## 2023 STANDARD DETAILS Summary of Changes

### D-101 STREET SECTIONS JOINT LAYOUT MONUMENT BOX

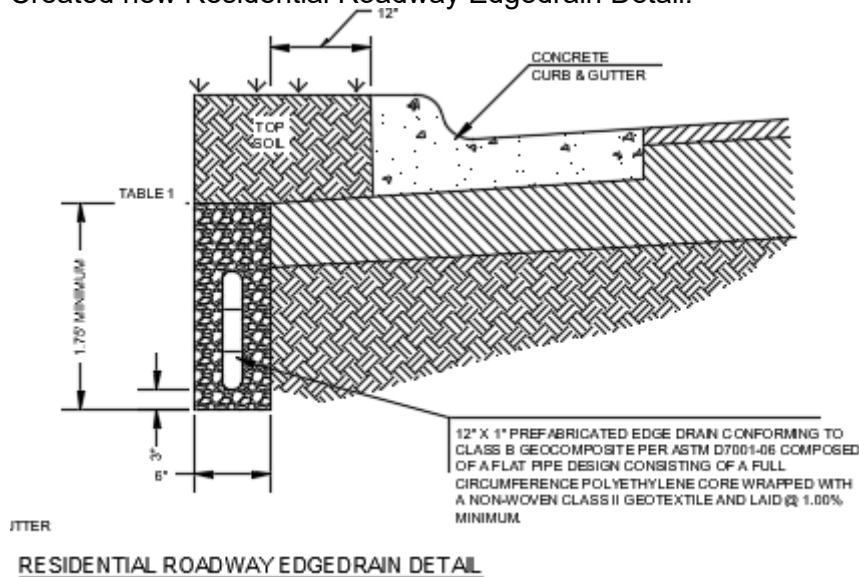
1. Revised Residential Street Section to require Type A Curb with full depth face 8".
2. Revised Residential Street Section to require 2" Surface, 2" Intermediate Course, and 4" Base Course.
3. Revised Major Street Section to reflect Surface, Intermediate Course, and Base. Revised the table to clarify the thickness of Surface, Intermediate Course, and Base with corresponding KCMMB mix requirement.
4. Revised Major Street Section Table to specify asphalt thickness and KCMMB asphalt material for each street type.
